SERVICE BULLETIN

| BT14-016 | NTB14-063 | July 8, 2014 |

370Z ROADSTER; STORAGE LID RUBS THE FIFTH BOW WHEN OPENING THE SOFT TOP

APPLIED VEHICLE: 2010-2014 370Z Roadster (Z34)

Figure 2

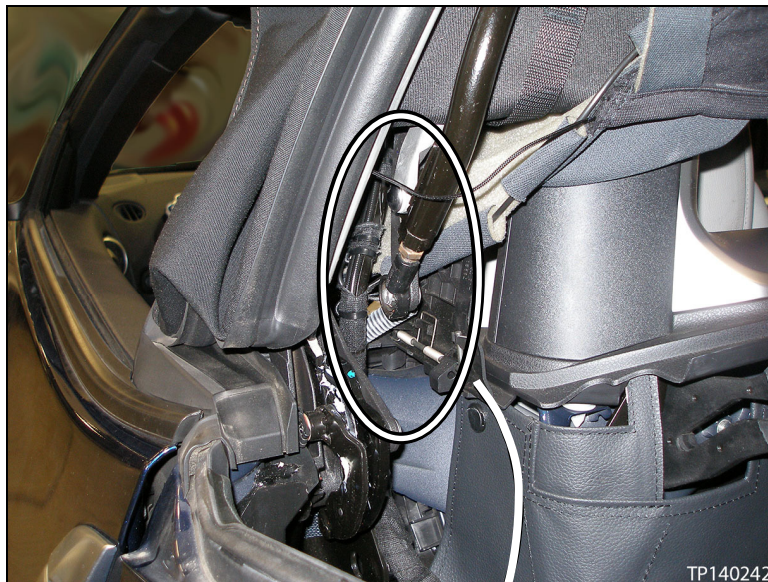
2. Saturate both pressure link pivot joints with WD-40® or equivalent lubricant (see Figure 2).
3. Adjust both pressure links:
 - a. Loosen the lock nut.
 - b. Turn the coupling nut one (1) full turn counter clockwise.
 - c. Tighten the lock nut.

Figure 4

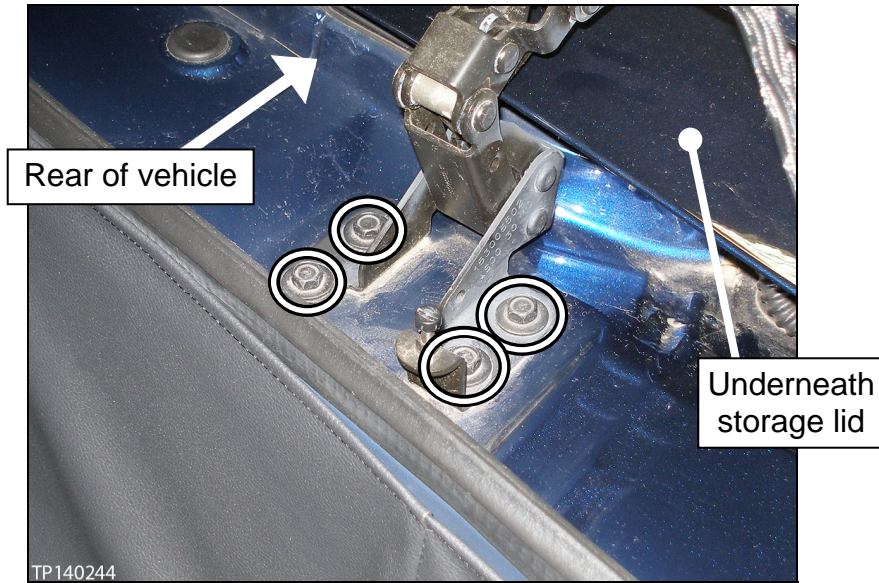
3. Adjust both storage lid hinges 0.5 mm (0.020 inches) toward the rear of the vehicle (see Figure 4).

- Storage lid hinge bolts torque: 17.0 N•m (1.7 kg-m, **13 ft lbs**)
